Service Bulletin

Bulletin No.: 17-NA-236

Subject: Rattle Noise from Front Door during Deep Bass Tones that May be Mistaken for Blown Speaker

4839330

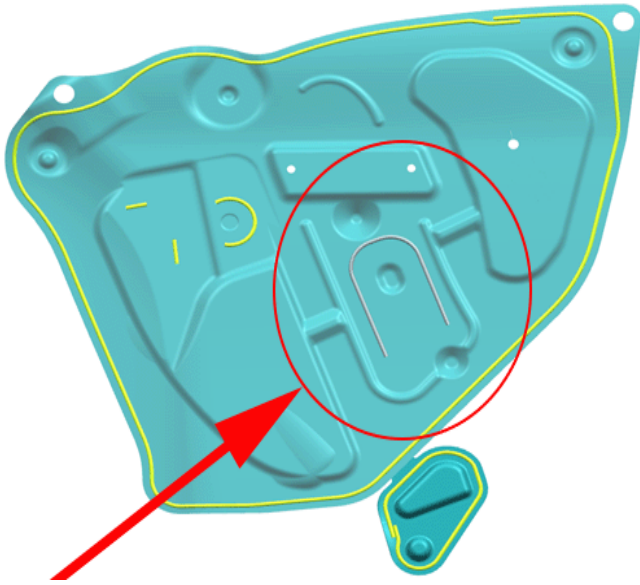
Once the noise is verified, push on the interior door trim panel in different locations while the noise is happening. If the noise changes, the noise is coming from the interior door trim panel and this bulletin does not apply. If the noise does not change, remove the interior trim panel and apply pressure to the suspect

location of the plastic water deflector shown above. Refer to the *Front Side Door Trim Replacement* procedure in SI.

If the noise is eliminated by applying pressure to the area of the plastic water deflector shown above, remove the deflector, and apply butyl tape between the deflector and interior side of the door structure in the location circled above after ensuring that both surfaces are clean. Then, reassemble the door panel/deflector and re-evaluate the noise to ensure that it is repaired. Refer to the *Front Side Door Water Deflector Replacement* procedure in SI.
